Product Change Notice (PCN)

PCN Number: **PCN-0451185R-01**

Product(s) Affected: PJ-050B

<p>PCB LAYOUT TOP VIEW</p>	 <p>Recommended PCB Layout Top View</p>

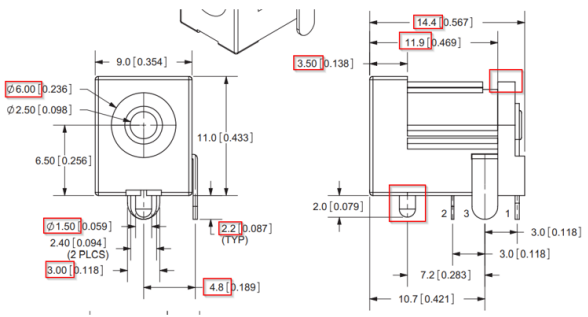
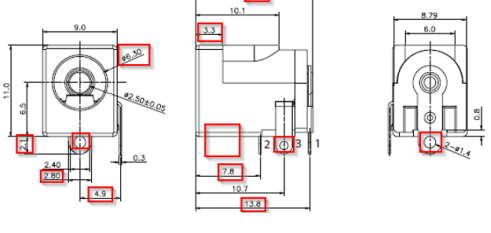
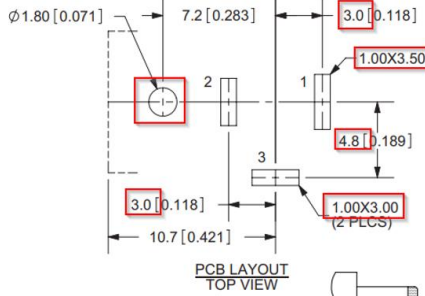
Description of Change: *Mechanical, electrical, and material changes as shown below:*

MATERIAL	PLATING
center pin	copper	nickel
terminal 1	brass	tin
terminal 2	copper alloy	tin
terminal 3	brass	tin
plastic	PBT

DESCRIPTION	MATERIAL	PLATING/COLOR
center pin	copper alloy (H65)	nickel
terminal 1	C2680 t=0.35	nickel-silver
terminal 2	C5210 t=0.25	nickel-silver
terminal 3	C2680 t=0.30	nickel-silver
cover	PA9T UL94V-0	black
housing	PA9T UL94V-0	black

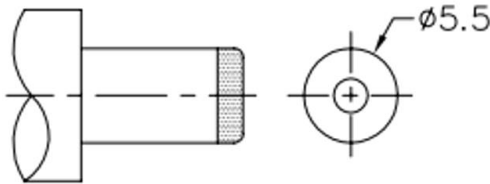
MATING PLUG
Jack Insertion Depth: 8.5 mm

MATING PLUG
Jack Insertion Depth: 9.6 mm
